HISTORIC AND DESIGN REVIEW COMMISSION

HDRC CASE NO:	2018-483
ADDRESS:	327 WICKES
LEGAL DESCRIPTION:	NCB 939 BLK 2 LOT 8
ZONING:	RM-4, HS
CITY COUNCIL DIST.:	1
DISTRICT:	King William Historic District
LANDMARK:	McCartney House
APPLICANT:	Ana Lisa Garza
OWNER:	Ana Lisa Garza
TYPE OF WORK:	Fence replacement including front driveway gate
APPLICATION RECEIVED:	September 12, 2018
60-DAY REVIEW:	November 11, 2018

The applicant is requesting a Certificate of Appropriateness for approval to replace a non-original fence with a 4-foot tall wrought iron front yard fence including a front driveway gate.

Classic

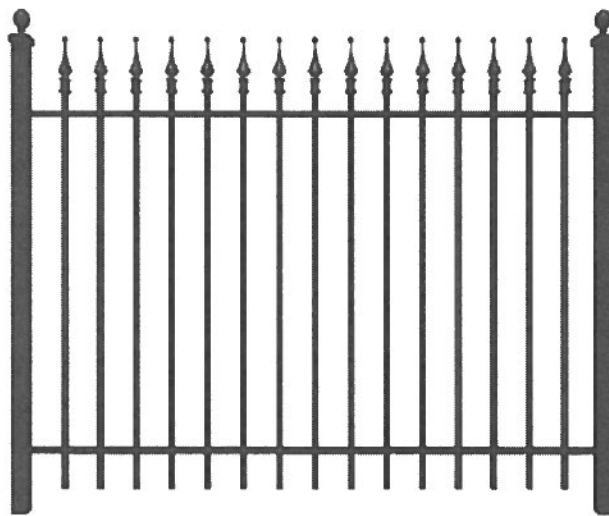
- d. FENCE DESIGN – The applicant has proposed the new fence to feature a wrought iron design and four feet in height. According to the Guidelines for Site Elements 2.B.i., the design of the fence should respond to the design and materials of the primary historic structure or structures of a similar style in the neighborhood in relation to scale, transparency, and character. Staff finds that the wrought iron fence is found within the Lavaca Historic District and with Folk Victorian homes.

- i. The fence should turn at the driveway to meet at the corner of the structure, as opposed to spanning across the driveway in the front.
- ii. The driveway gate should be located behind the front façade plane of the structure or removed from the design.
- iii. That no portion of the fence exceed four feet in height.
